# **The Town of Hilton Head Island Regular Design Review Board Meeting**

**Tuesday, May 25th, 2010**

## DESIGN TEAM/ DRB COMMENT SHEET

PROJECT Hilton Head Pizza Company

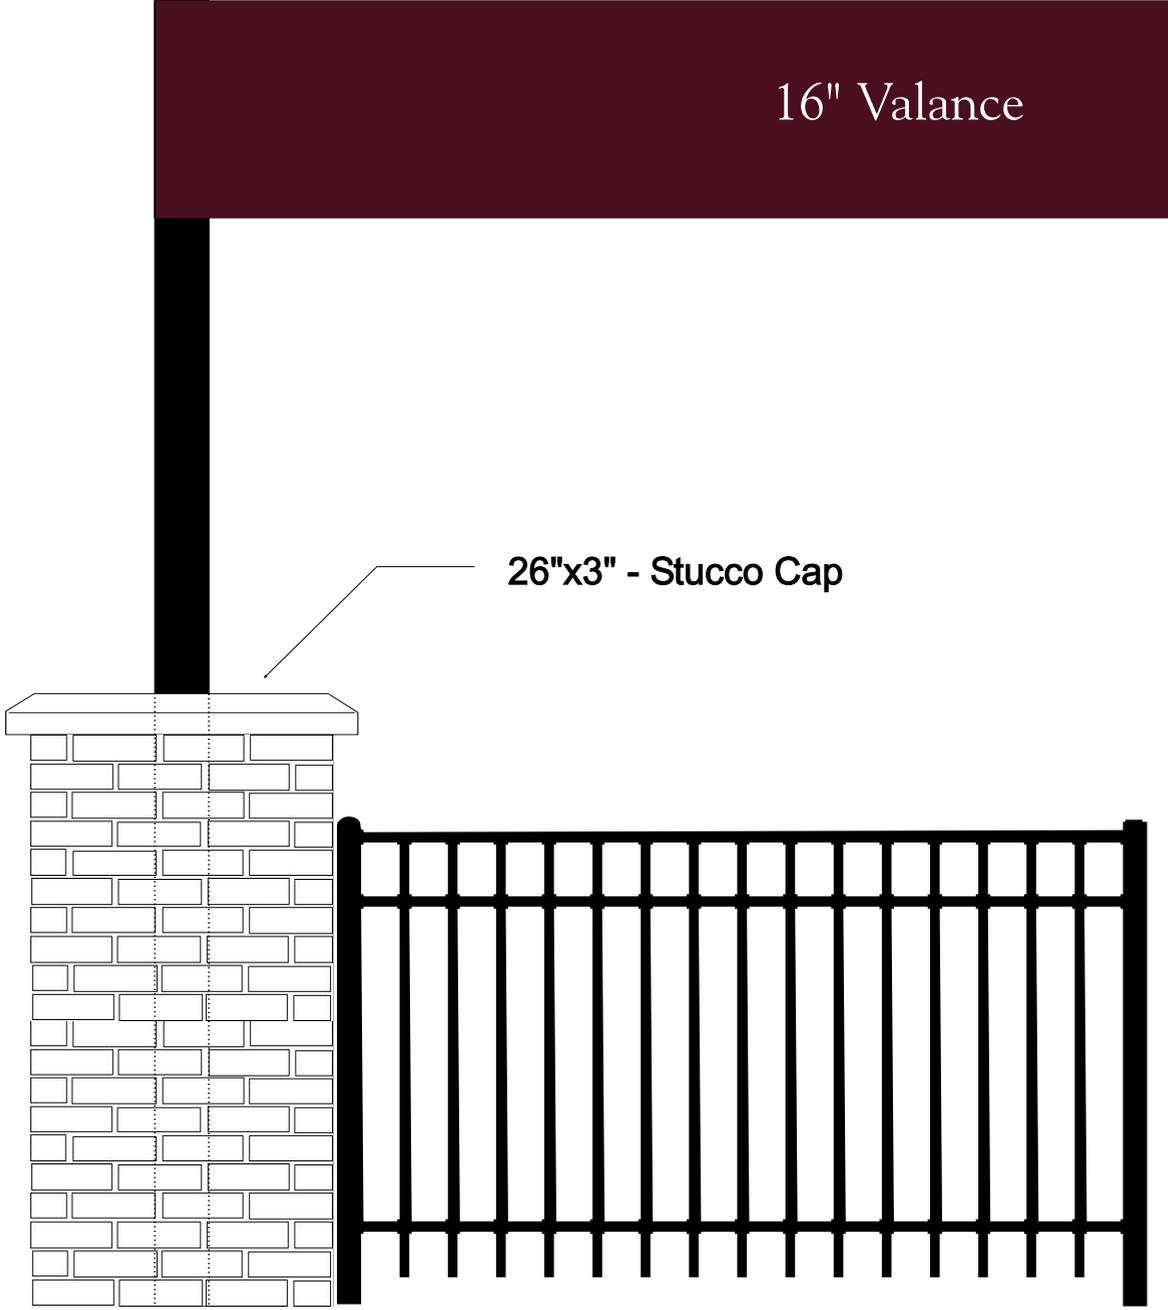
<b>ARCHITECTURAL DESIGN</b>		
<p>The column details appear massive relative to the metal posts. In an effort to align the new columns with those on the building, the panel accents on the building become partially obscured, exaggerating the canopy's lack of integration. The site plan details are still lacking, as are any definitive dimensions to the canopy itself. As presented, Staff would recommend denial. Staff will solicit further information and detail from applicant prior to the meeting.</p>		
DESIGN GUIDE/LMO CRITERIA	COMPLIES YES/NO/N/A	COMMENTS OR CONDITIONS
Structure is designed to be appropriate to the neighborhood		
Promotes pedestrian scale and circulation		
Design is unobtrusive and set into the natural environment		
Utilizes natural materials and colors		
Avoids distinctive vernacular styles		
Design is appropriate for its use		
All facades are have equal design characteristics		
Avoids monotonous planes or unrelieved repetition

PROJECT Wise Guys Canopy DRB# DR100024

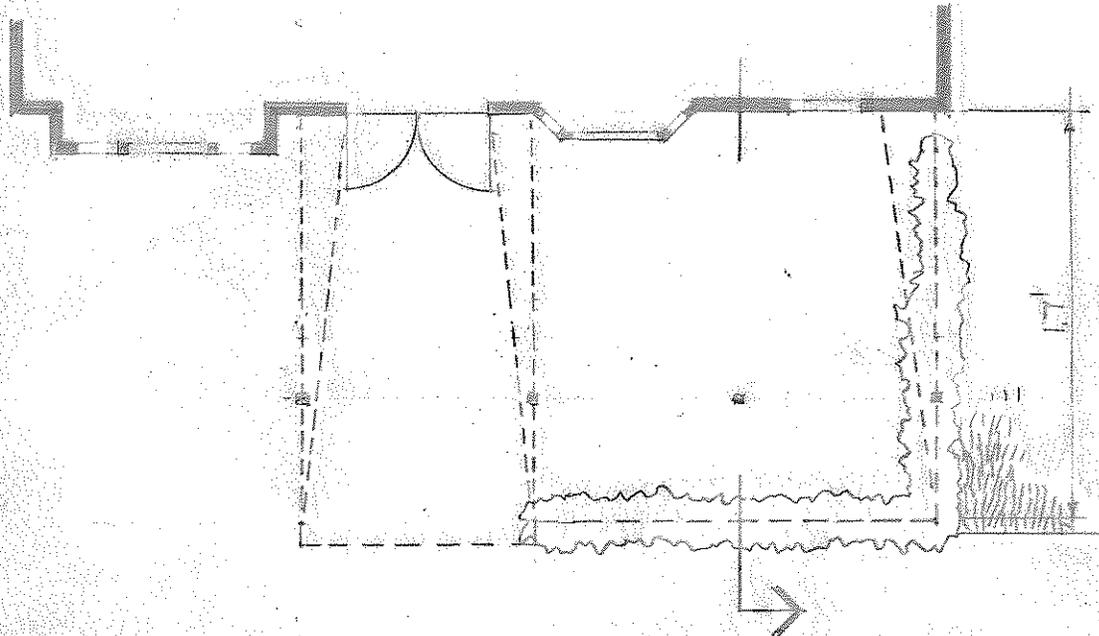
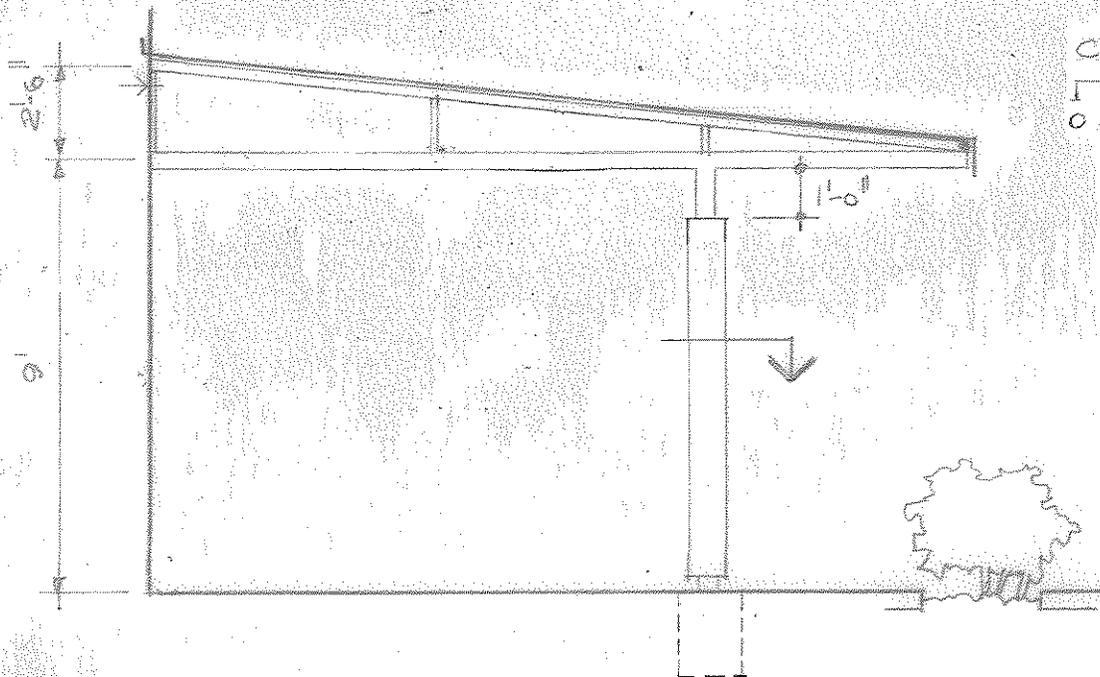
<b>ARCHITECTURAL DESIGN</b>		
Applicant has moved the posts further out on the canopy, as requested by the Board, but the proposed encasement of the post should be fleshed out and utilize some more detail. Staff would recommend approval with a further developed encasement detail.		
DESIGN GUIDE/LMO CRITERIA	COMPLIES YES/NO/N/A	COMMENTS OR CONDITIONS
Structure is designed to be appropriate to the neighborhood		
Promotes pedestrian scale and circulation		
Design is unobtrusive and set into the natural environment		
Utilizes natural materials and colors		
Avoids distinctive vernacular styles		
Design is appropriate for its use		
All facades are have equal design characteristics		
Avoids monotonous planes or unrelieved repetition		
Has a strong roof form with enough variety to provide visual interest		
Minimum roof pitch of 6/12		
Overhangs are sufficient for the façade height.		
Forms an details are sufficient to reduce the mass of the structure

L-1

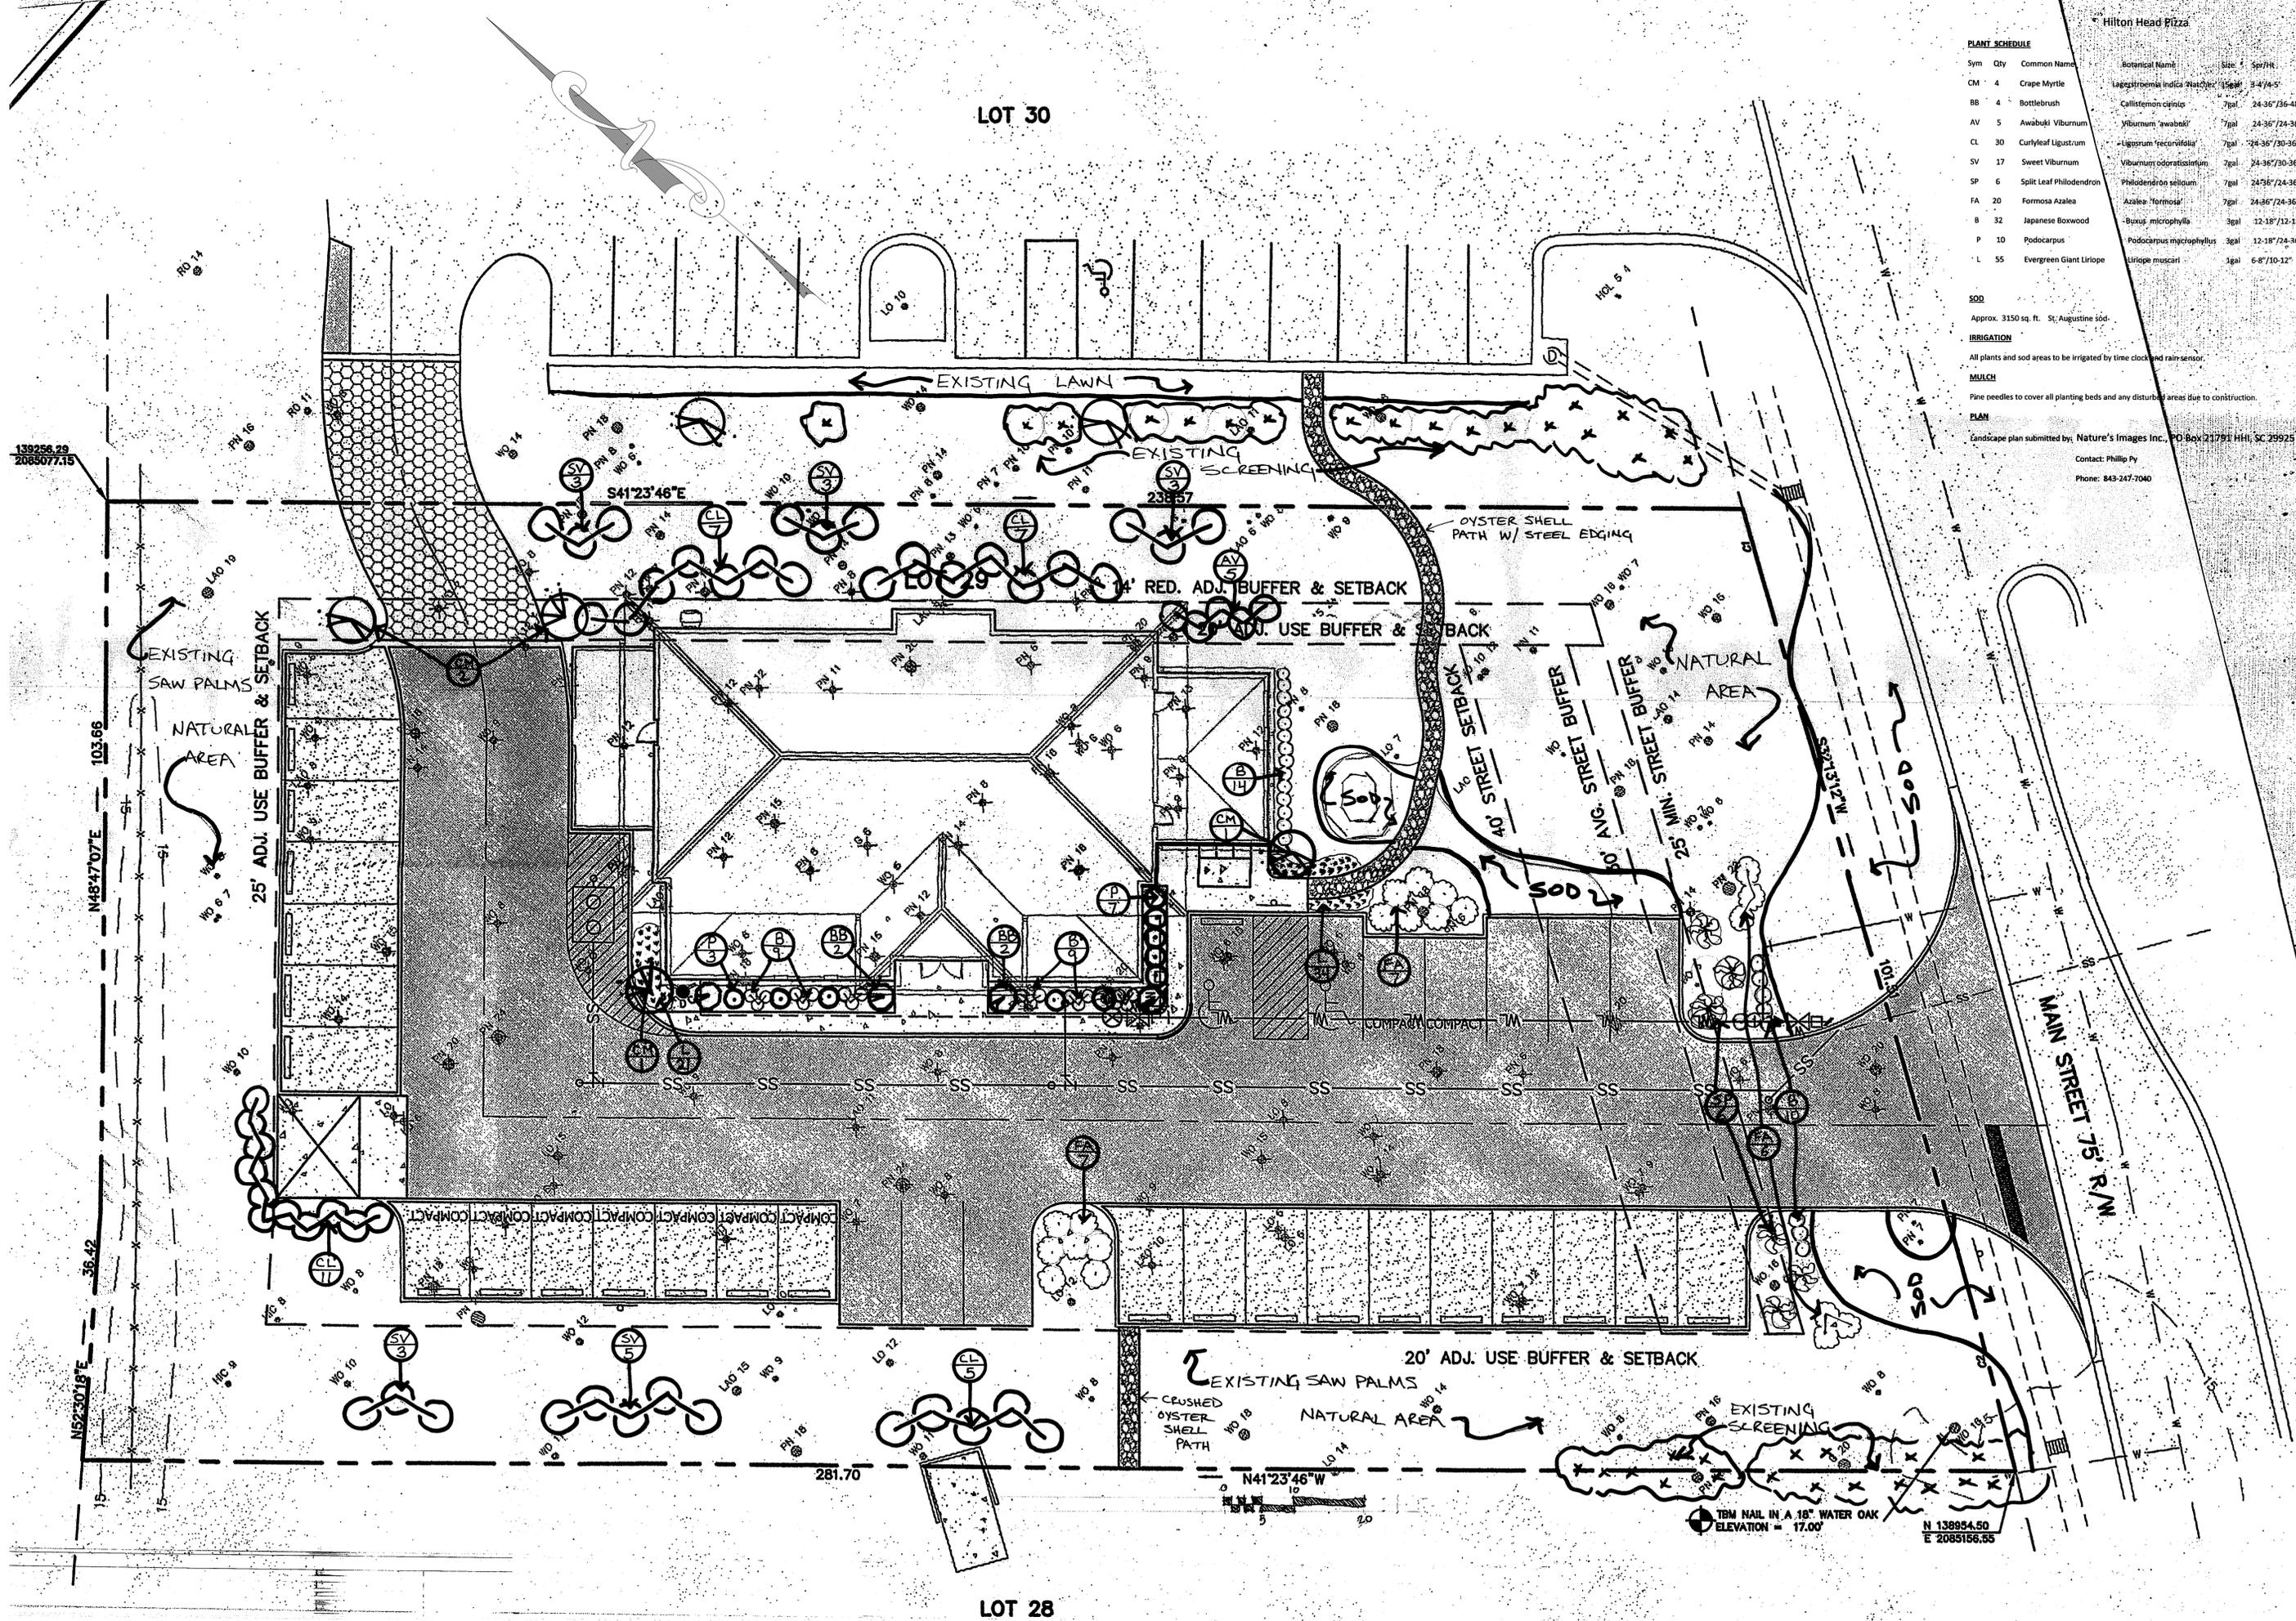
DESIGN GUIDE/LMO CRITERIA	COMPLIES YES/NO/NA	COMMENTS OR CONDITIONS
Treats the Landscape as a major element of the project	Y/N	Limited landscape plan, but lack of material actually preserves the natural character of the site
Provides Landscaping of a scope and size that is in proportion to the scale of the development	Y/N	After putting windows in the dining room, the landscape plan contemplates blocking them with material upon maturity. Conversely, the long, unadorned rear elevation beyond the dining room receives 7 gallon material that will do little to soften the immediate impact of development
Landscape is designed so that it may be maintained in its natural shape and size	Y	
Preserves a variety of existing native trees and shrubs	Y	
Provides for a harmonious setting for the site's structures, parking areas or other construction	Y	
Location of existing trees and new trees provides street buffers, mitigation for parking lots, and an architectural complement that visually mitigates between parking lots and building(s)	Y

Shrubs are selected to complement the natural setting, provide visual interest and screen less desirable elements of the project	Y	Adjacent property buffer is addressed well. Character of landscape at drive aisle between lots should carry across the property line
A variety of species is selected for texture and color	Y	
Provides overall order and	Y

continuity of the Landscape plan		
Native plants or plants that have historically been prevalent on the Island are utilized	Y/N	Japanese boxwood is a very formal plant and limited in precedence. The proposed application is usually, and more successfully, accomplished with dwarf yaupon holly
A variety of sizes is selected to create a "layered" appearance for visual interest and a sense of depth	Y	
The location of existing mature trees is taken into account in placement of shrubs so as not to damage tree roots	Y	
Proper spacing and location for plants to reach their mature size and natural shape while avoiding excessive or unnatural pruning	Y	
Proposed groundcovers are evergreen species with low maintenance needs	Y	
Large grassed lawn areas encompassing a major portion of the site are avoided	Y	The sod area seems to provide little aesthetic function, and will likely denigrate as it becomes an alternate route from the parking to the building. Continuation of the massing of azalea or liriopé might be more successful
